Access Compliance Report Public Rights-of-Way (Curb Ramps)

Intersection ID: 9951 Main Street: S_TURNER_AV Cross Street: W_TRADE_ST Location: SE

ADA ID: 40DE906D82B6 Ramp Type: Perp Initial Pass/Fail: Fail Overall Compliance: No Severity Score: 12.5

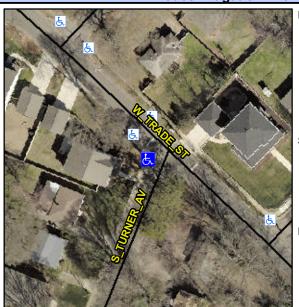
Not Found, R304.5.3

Field Measurements/Component Compliance						
	Compliance Description		Data	Compliance Description		Data
	N/A	Ramp Length (in)	60.0	Yes	Ramp Slope (%)	5.5
	Yes	Ramp Width (in)	48.0	No	Ramp XSlope (%)	5.1
	N/A	Flare Type LT	N/A	N/A	Flare Type RT	N/A
	N/A	Flare Slope LT (%)	N/A	N/A	Flare Slope RT (%)	N/A
	N/A	Flare Traversable LT?	N/A	N/A	Flare Traversable RT?	N/A
	N/A	Landing Length (in)	N/A	N/A	DWS Provided?	N/A
	N/A	Landing Width (in)	N/A	N/A	DWS Contrast?	N/A
	N/A	Landing Slope (%)	N/A	N/A	DWS Length (in)	N/A
	N/A	Landing X Slope (%)	N/A	N/A	DWS Full Width?	N/A
	N/A	Landing Curb? (Y/N)	N/A	N/A	DWS Offset (in)	N/A
	N/A	Shared Landing?	N/A			
	N/A	Gutter Ponding?	N/A	N/A	Gutter Slope (%)	N/A
	N/A	Gutter Lip Ht (in)	N/A	N/A	Gutter X Slope (%)	N/A
	N/A	Painted X Walk1?	No	N/A	Painted X Walk2?	N/A
		X Walk 1 Direction	To SE		X Walk 2 Direction	N/A
	N/A	X Walk 1 Width (in)	N/A	N/A	X Walk 2 Width (in)	N/A
		X Walk 1 Slope (%)	6.0		X Walk 2 Slope (%)	N/A

Remove & Replace Entire Ramp.
